ZONING BOARD OF APPEALS

Thursday, May 23, 2019

AGENDA

ZONING BOARD OF APPEALS
Draft Minutes
Thursday, March 28, 2019
6:00 pm
Council Board Room
One Batavia City Centre, Batavia, NY

A PROPOSED SITE LAYOUT
Scale: 1"=20'

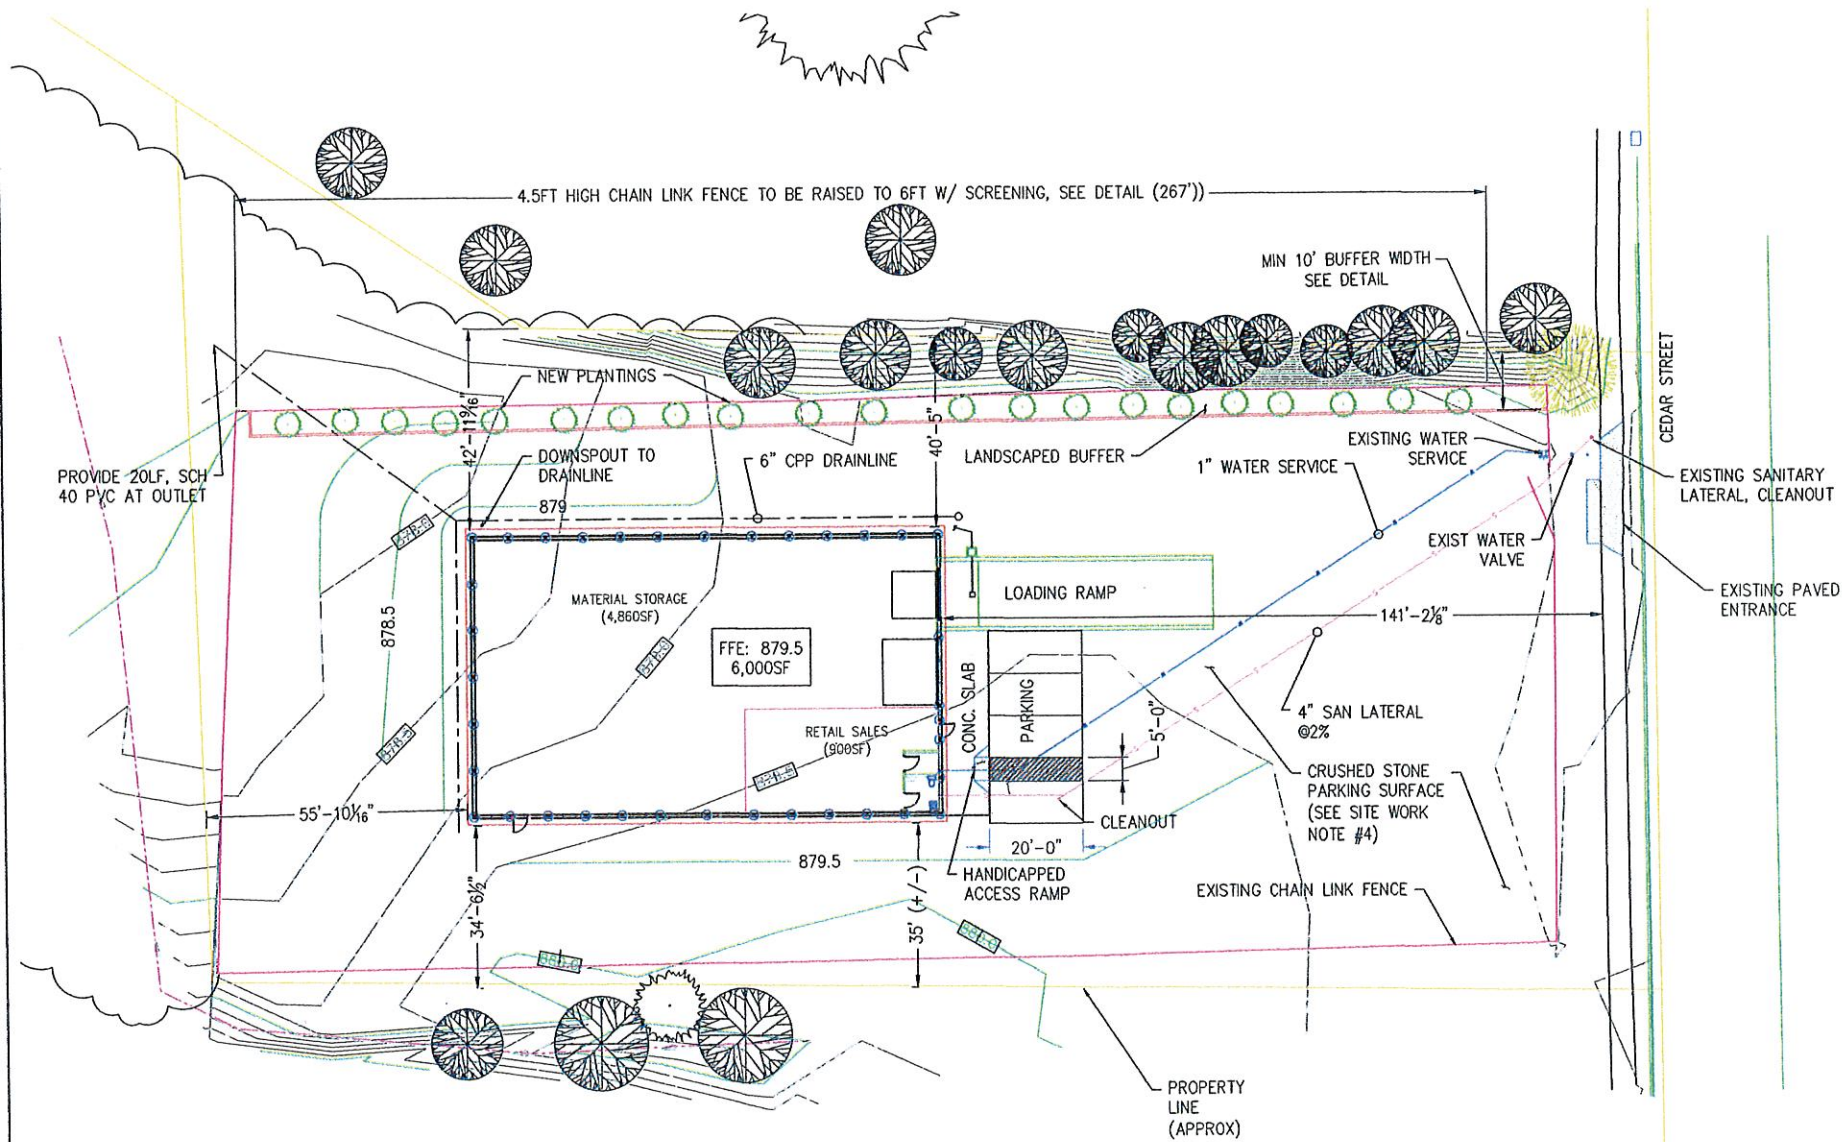
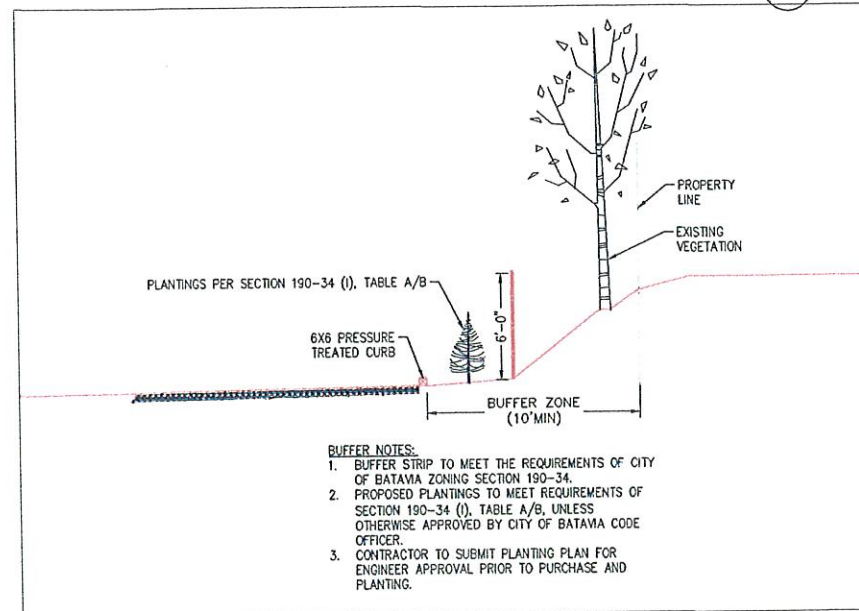
- 1) BMC 190-39 B(a) Parking shall be located behind or to the side of the principal building. The plan indicates parking across the front of the building.

Given that there is existing parking in the front of the property and that adjacent businesses exhibit similar parking patterns, the proposed building and variance should pose no significant county-wide or inter-community impact. The proposed vegetative buffer should mitigate any impacts on the adjacent residence.
